HICKMAN'S WAY SUBDIVISION

APPLICATION NUMBER 15 DATE January 16, 2014

REQUEST Subdivision

DETAIL SITE PLAN

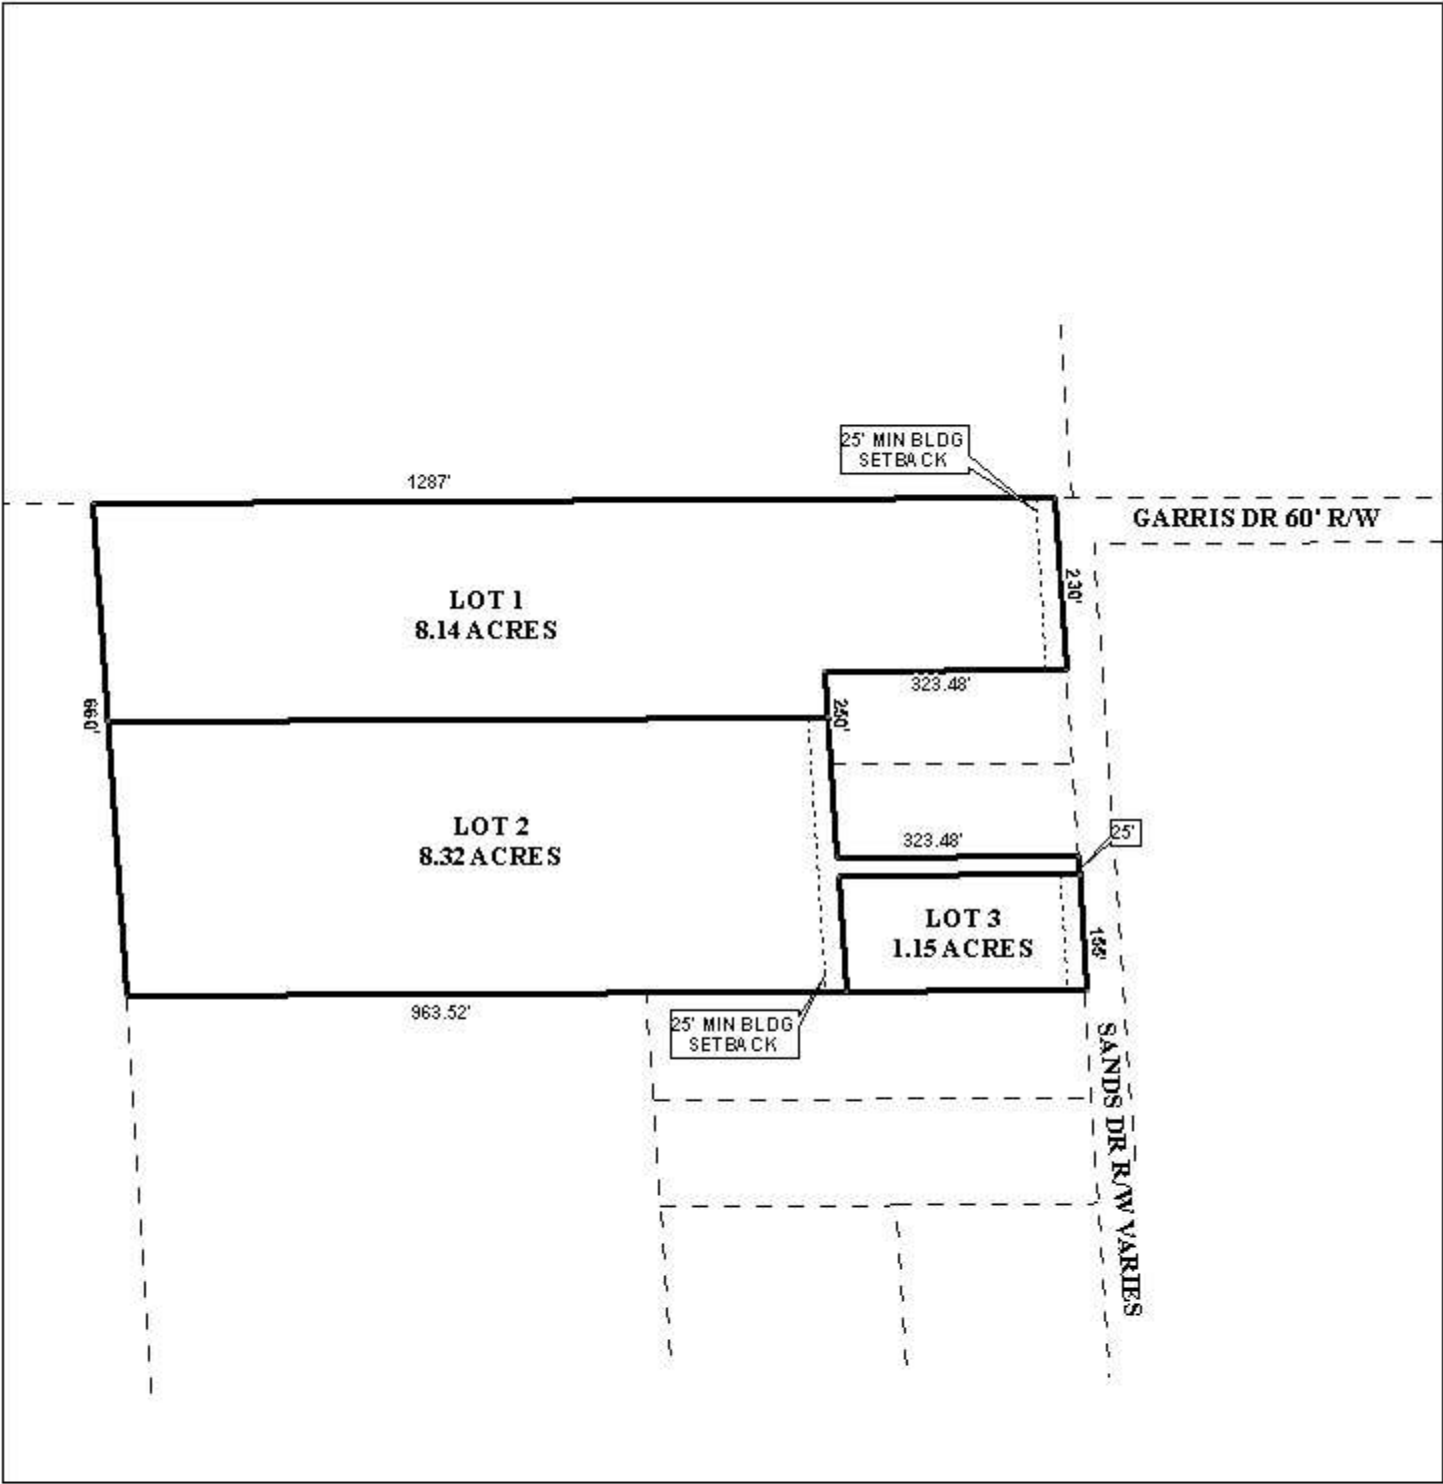
Ingress/egress for the proposed Lot 2 would be via the pole portion of the lot which measures 25' wide by 383' ± long and although the flag portion of the lot measures 368' ± wide and 963' ± deep, only 25' of frontage along a public street would be provided. Due to the limited frontage, if approved, future subdivision of the proposed Lot 2 should be prohibited until additional frontage along a public or private street is provided. This note should appear on the Final Plat if approved.

In accordance with the Subdivision Regulations, all three proposed lots exceed the minimum lot size requirements and the 25-foot minimum building setback line is depicted on the preliminary plat but should be revised for the proposed Lot 2 and depicted as a box where the "flag" meets the "pole" of the lot and retained elsewhere on the Final Plat, if approved.

The proposed subdivision has frontage along Sands Drive, a minor street without curb and gutter. The preliminary plat illustrates a varying right-of-way, however, according to the Section V.B.14. of the Subdivision Regulations, the right-of-way should be 60'. As a result, the current right of way may not be sufficient and, as such, dedication, if needed, should be required to provide 30' as measured from centerline.

It is important to note that the Major Street Plan component of the Comprehensive Plan illustrates a proposed Major Street which is planned to run along the Western boundary of the proposed Lots 1 and 2 of Hickman's Way Subdivision. The proposed right-of-way is 100' and, as such, would require 50' of right-of-way on either side of the centerline. There have been other subdivisions approved by the Planning Commission which front a portion of the proposed route of the proposed Major Street, and instead of requiring dedication to provide 50' of right-of-way from the proposed centerline, the Commission instead, required a 75' setback, which included the 50' as measured from centerline and an additional 25' for a front-yard setback. As there are no known immediate plans for street's construction, this request should be considered in a similar manner, thus, the Final Plat should be revised to illustrate a 75' setback along the Western lot line of the proposed Lots 1 and 2, if approved.

The site has 2 existing curb-cuts, one for the proposed Lot 1 and another for the proposed Lot 3. As a means of access management, a note should be placed on the Final Plat stating that the proposed Lot 2 be limited to one curb-cut and the proposed Lots 1 and 3 be limited to the existing curb-cuts. The additional curb-cut along with any changes to the existing curb-cut are to be approved by Mobile County Engineering and conform to AASHTO standards.

- 1) Placement of a note on the Final Plat stating that no future subdivision of Lot 2 will be allowed until additional frontage along a paved public street is provided;

- 2) Dedication for all proposed lots to provide 30' of right-of-way along Sands Drive as measured from centerline;
- 3) Revision of the 25' minimum setback line to reflect dedication and to be depicted as a box where the "flag" meets the "pole" of Lot 2 on the Final Plat;

- 4) Revision of lot size information to reflect dedication;
- 5) Illustration of a 75' setback along the Western lot line of Lots 1 and 2 on the Final Plat;

- 6) Placement of a note on the Final Plat limiting Lot 2 to one curb-cut to Sands Drive and Lots 1 and 3 to the existing curb-cuts along Sands Drive. The additional curb-cut along with any changes to the existing curb-cuts are to be approved by Mobile County Engineering and conform to AASHTO standards;

- 7) Placement of a note on the Final Plat stating that Lots 1 and 2 are denied access to Eliza Jordan Road, a proposed Major street;
- 8) Compliance with Engineering Comments and placement of a note on the Final Plat stating: *(Must comply with the Mobile County Flood Damage Prevention Ordinance. Development shall be designed to comply with the storm water detention and drainage facility requirements of the City of Mobile storm water and flood control ordinances, and requiring submission of certification from a licensed engineer certifying that the design complies with the storm water detention and drainage facility requirements of the City of Mobile storm water and flood control ordinances prior to the issuance of any permits.);*
